**CITY OF TACOMA
TACOMA POWER**

ADDENDUM NO. 1

Request for Bids Specification No. PG21-0045F

Mayfield Water System Replacement and Road Realignment

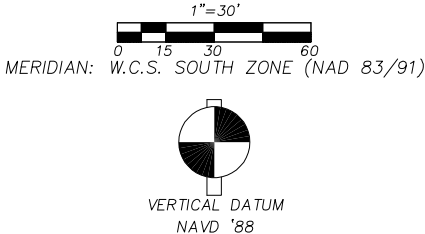
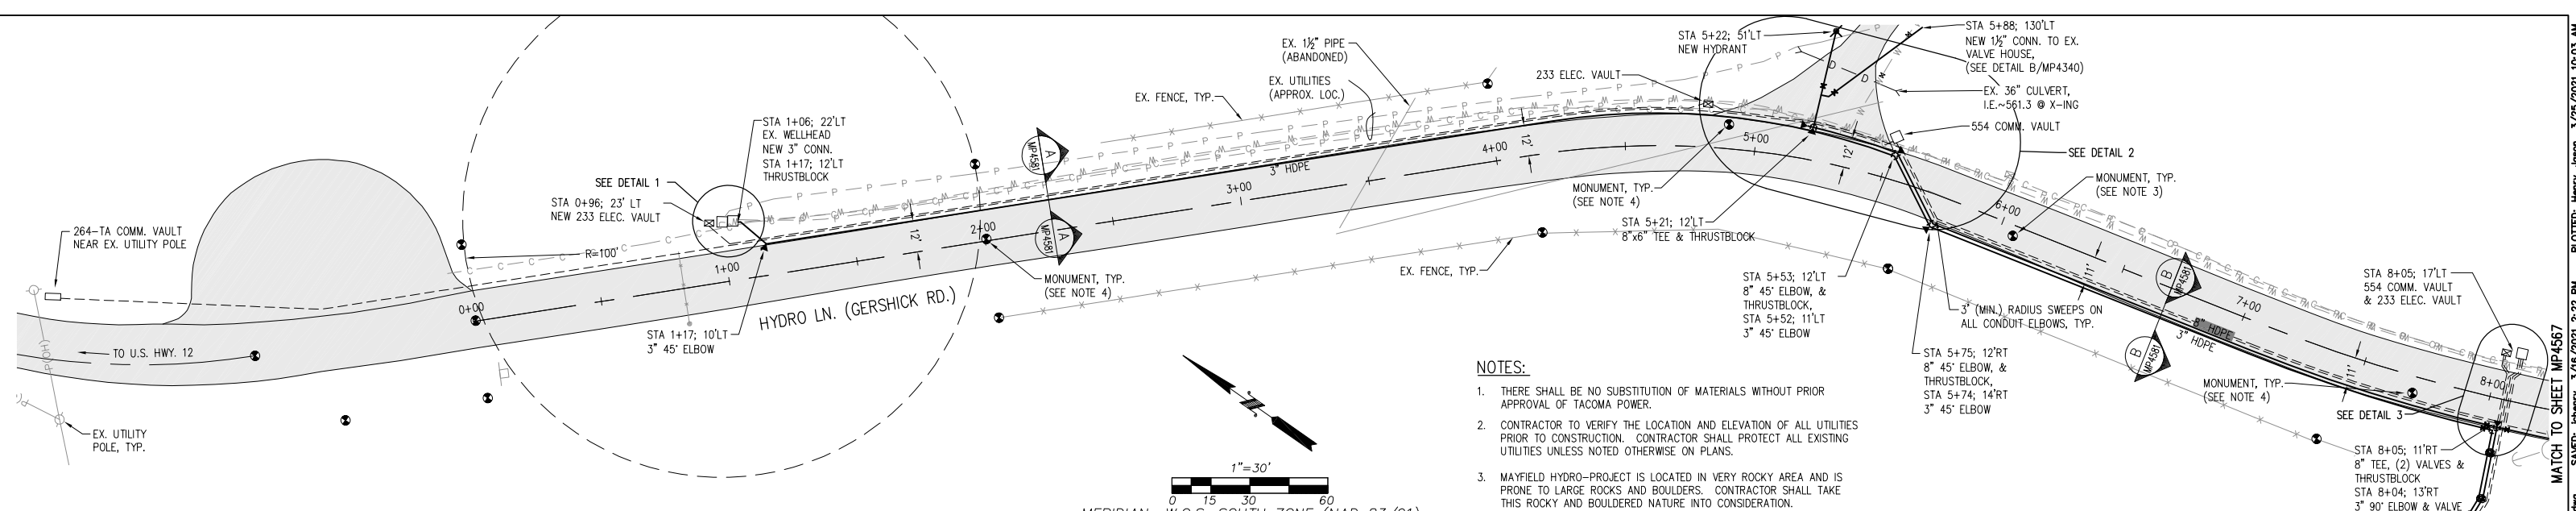
- 1) Replace Drawing MP4561 with drawing provided with addendum.
- 2) Replace Drawing MP4566 with drawing provided with addendum.
- 3) Remove Drawing MP4572-**B** from specification (NOTE: Retain Drawing MP4572).
